**Special Service Campaign (SSC) 60D
Certain Early 2007 Model Year FJ Cruiser Vehicles**

CHANGE TO TECHNICAL INSTRUCTIONS!

TECHNICAL INSTRUCTIONS

REVISED August 2, 2006

A. TIRES INVOLVED IN SSC 60D

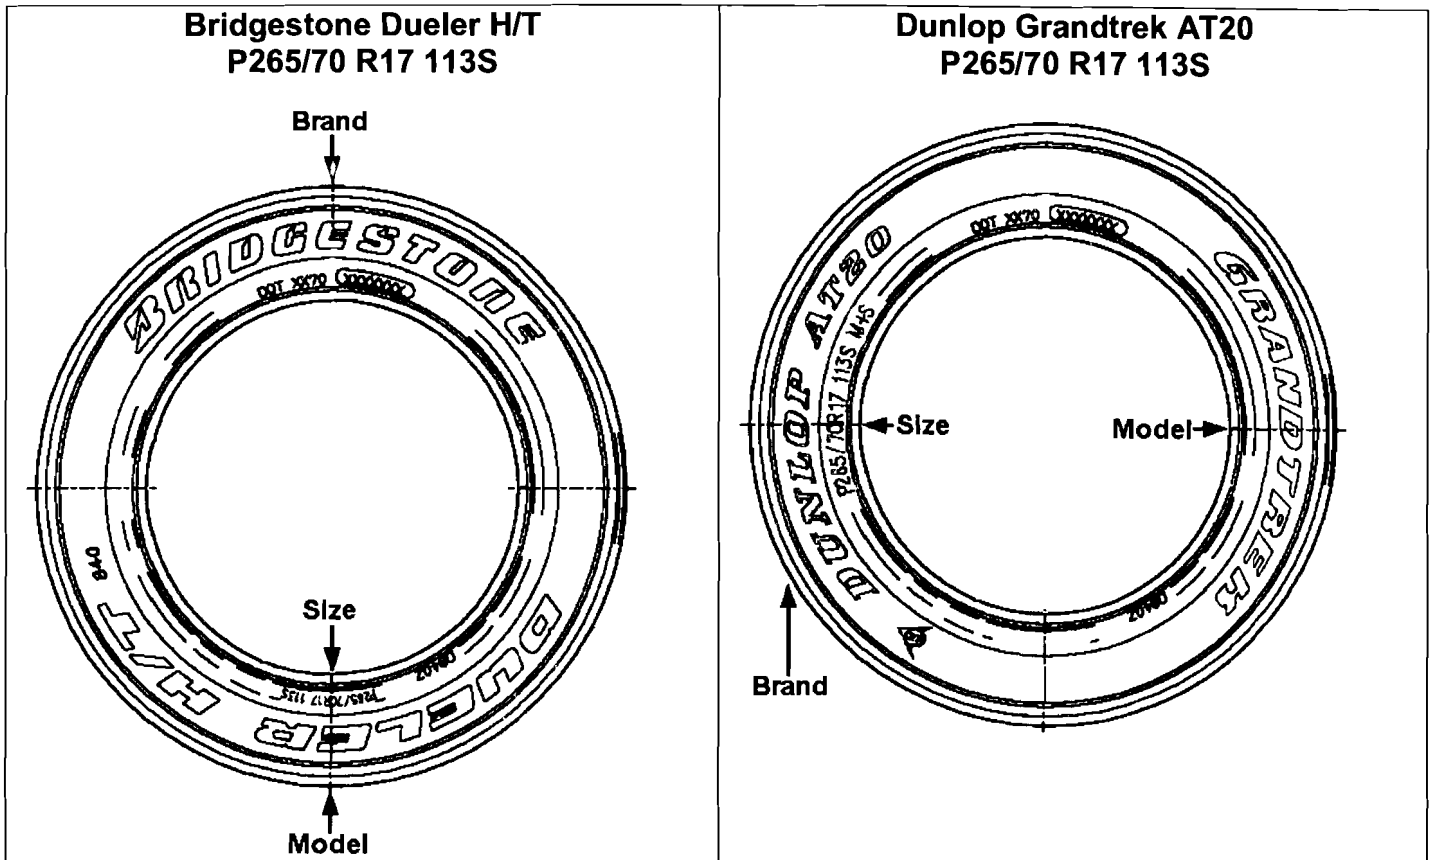
- If the tires are the applicable Bridgestone or Dunlop brand/size, replace the tires.
- **DO NOT** check the tires for damage. (The damage may be difficult to find.)
- **DO NOT** check the DOT Serial Number. Simply replace the tires if they are the applicable Bridgestone or Dunlop Tire.
